Peat Depth

Mossy Hill Wind Farm

Non-Material Variation to 2023/084/VCON (2018/186/PPF)

Figure 2a

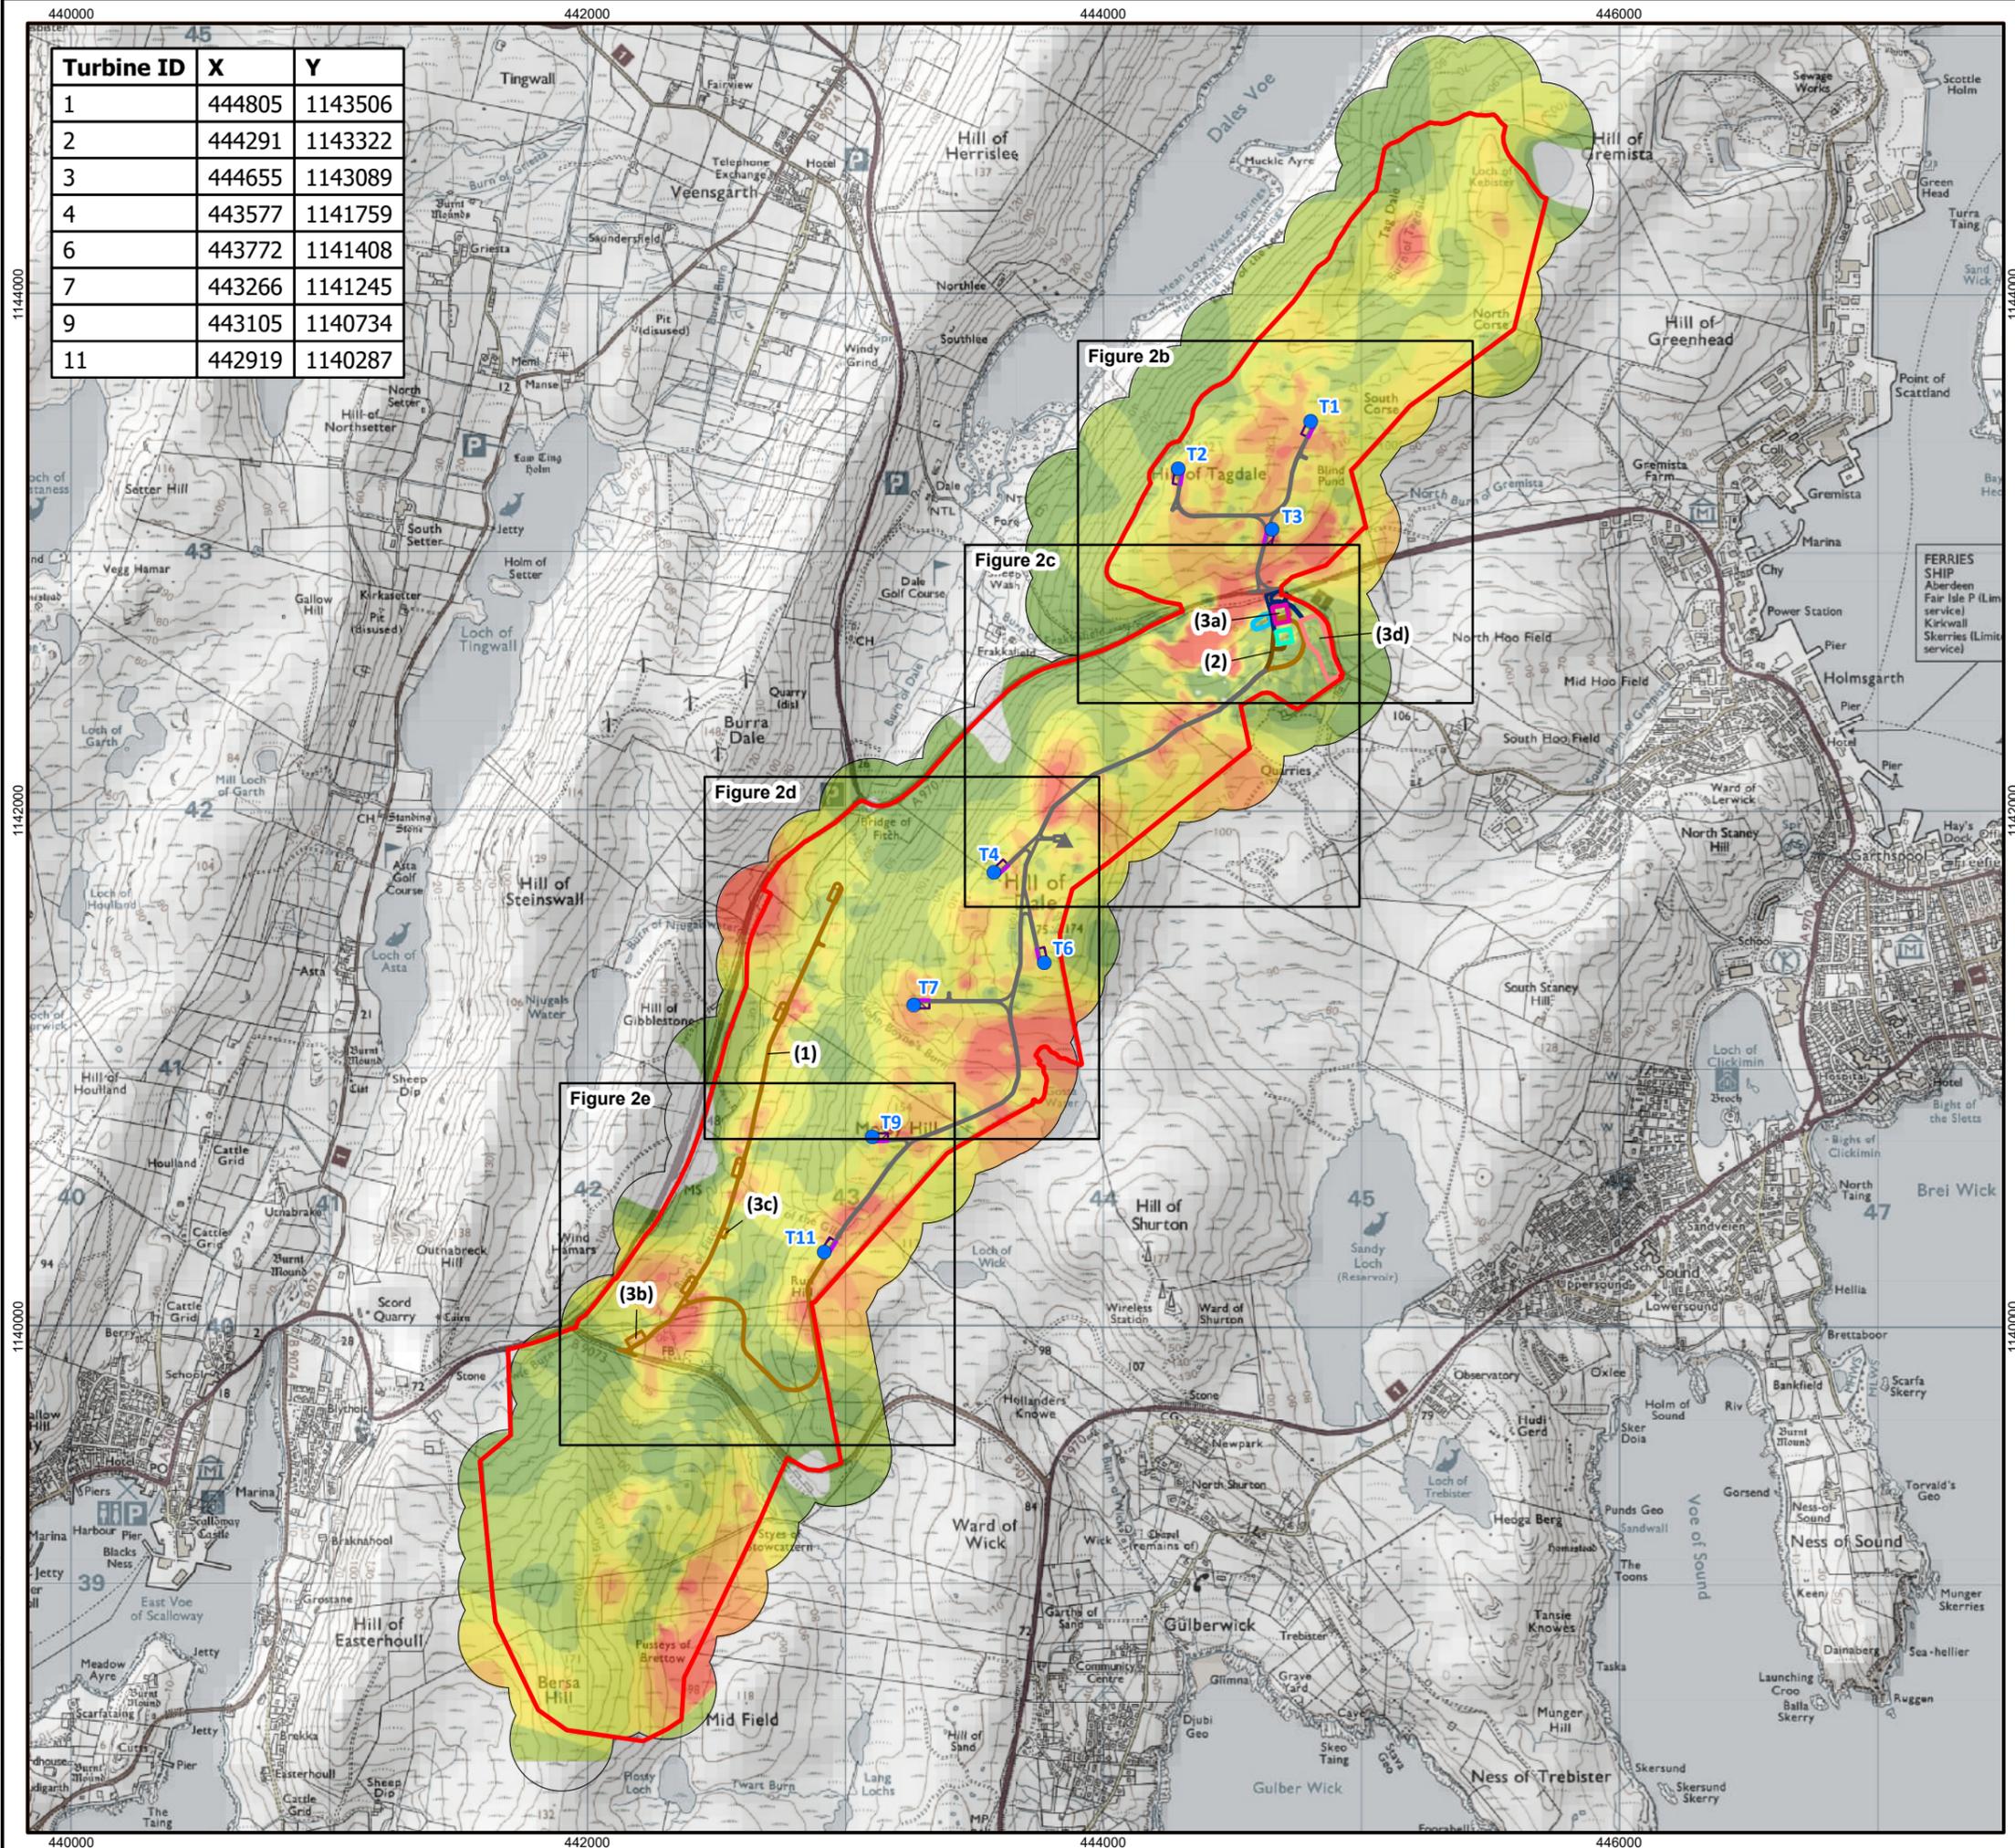
- (1) Removal of Turbines T5, T8, T10, T12, associated infrastructure, tracks and the B9073 access junction
- (2) Amendment to the track linking the consented substation to wind farm track, removing loop and shortening length. Addition of link tracks to construction compounds
- (3a) Relocation of northern wind farm temporary construction compound
- (3b) Removal of southern temporary construction compound
- (3c) Removal of southern substation
- (3d) Revised substation design and layout as approved via planning permission Ref: 2024/303/PPF granted on 12th June 2025

Figure 2b

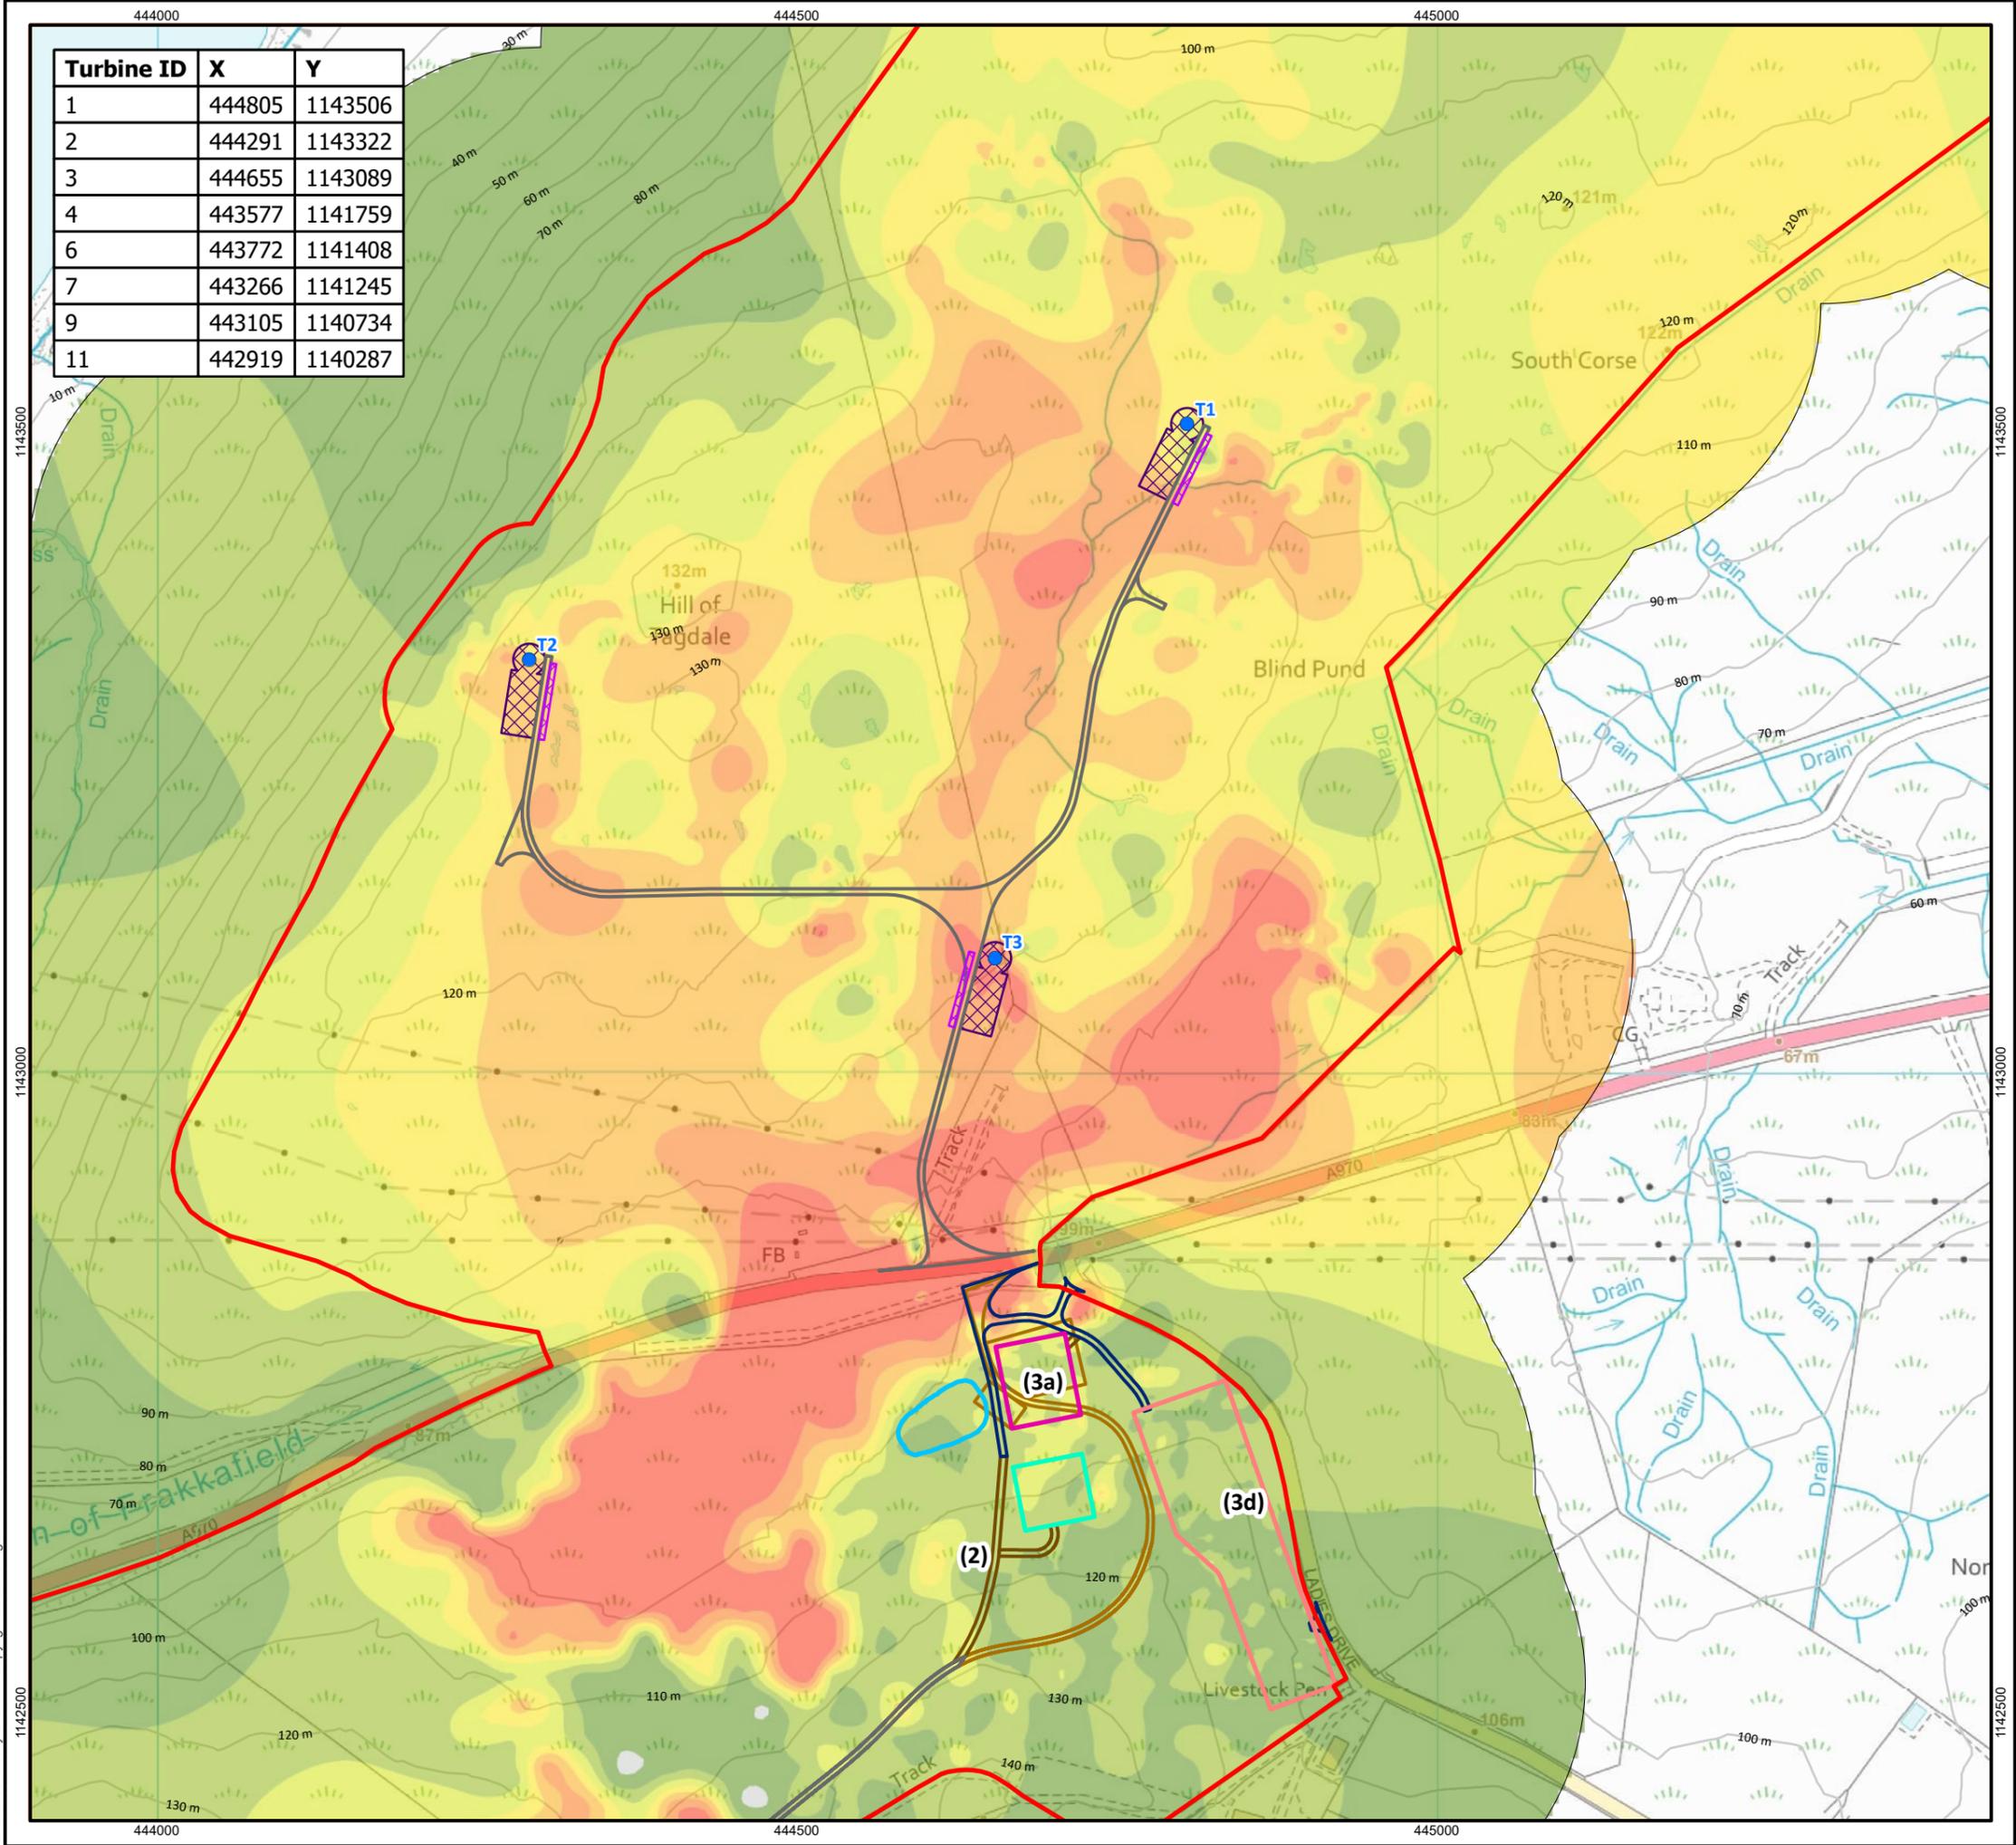
- (1) Removal of Turbines T5, T8, T10, T12, associated infrastructure, tracks and the B9073 access junction
- (2) Amendment to the track linking the consented substation to wind farm track, removing loop and shortening length. Addition of link tracks to construction compounds
- (3a) Relocation of northern wind farm temporary construction compound
- (3b) Removal of southern temporary construction compound
- (3c) Removal of southern substation
- (3d) Revised substation design and layout as approved via planning permission Ref: 2024/303/PPF granted on 12th June 2025
